Access Compliance Report

Public Rights-of-Way

(Curb Ramps)

Intersection ID: 15707	Main Street: DORCHESTER_PL	Cross Street: POINDEXTER_DR	Location:	S
ADA ID: 9A431BA658AB	Ramp Type: ParaDiag	Initial Pass/Fail: Fail	Overall Compliance: No	Severity Score: 30
Codes/Mitigation Info/Possible Solution		Field Measurements/Component Compliance

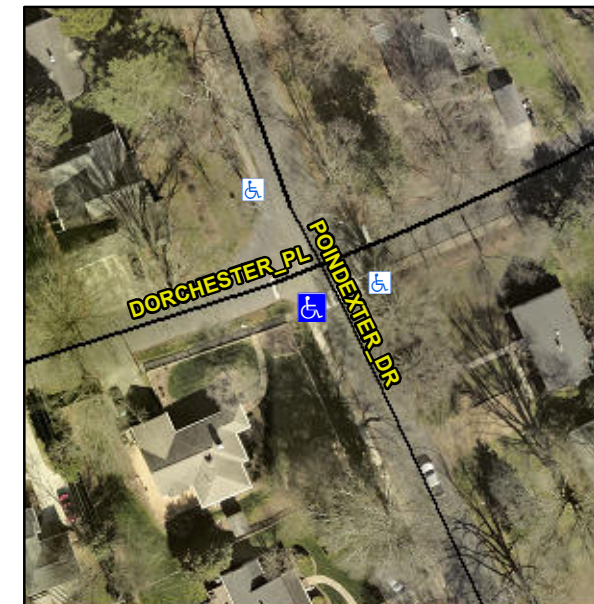
Surveyor Notes:

NO CURB

PROW/ADA:

R304.5.1, R304.3.2

Compliance	Description	Data	Compliance	Description	Data
N/A	Ramp Length LT (in)	64.0	N/A	Ramp Length RT (in)	N/A
No	Ramp Width LT (in)	35.0	N/A	Ramp Width RT (in)	N/A
No	Ramp Slope LT (%)	8.5	N/A	Ramp Slope RT (%)	N/A
Yes	Ramp XSlope LT (%)	1.5	N/A	Ramp XSlope RT (%)	N/A
N/A	Landing Length (in)	N/A	N/A	DWS Provided?	N/A
N/A	Landing Width (in)	N/A	N/A	DWS Contrast?	N/A
N/A	Landing Slope (%)	N/A	N/A	DWS Length (in)	N/A
N/A	Landing X Slope (%)	N/A	N/A	DWS Full Width?	N/A
N/A	Landing Curb? (Y/N)	N/A	N/A	DWS Offset (in)	N/A
N/A	Shared Landing?	N/A			
N/A	Gutter Ponding?	N/A	N/A	Gutter Slope (%)	N/A
N/A	Gutter Lip Ht (in)	N/A	N/A	Gutter X Slope (%)	N/A
N/A	Painted X Walk1?	Yes	N/A	Painted X Walk2?	No
	X Walk 1 Direction	To NE		X Walk 2 Direction	To NW
N/A	X Walk 1 Width (in)	84.0	N/A	X Walk 2 Width (in)	N/A
	X Walk 1 Slope (%)	1.9		X Walk 2 Slope (%)	0.1
	X Walk 1 X Slope (%)	1.0		X Walk 2 X Slope (%)	2.0
N/A	Ramp inside XWalk1?	Yes	N/A	Ramp inside XWalk2?	N/A

Possible Solutions:

Remove & Replace Curb Ramp With Two New Directional Ramps or Equivalent.
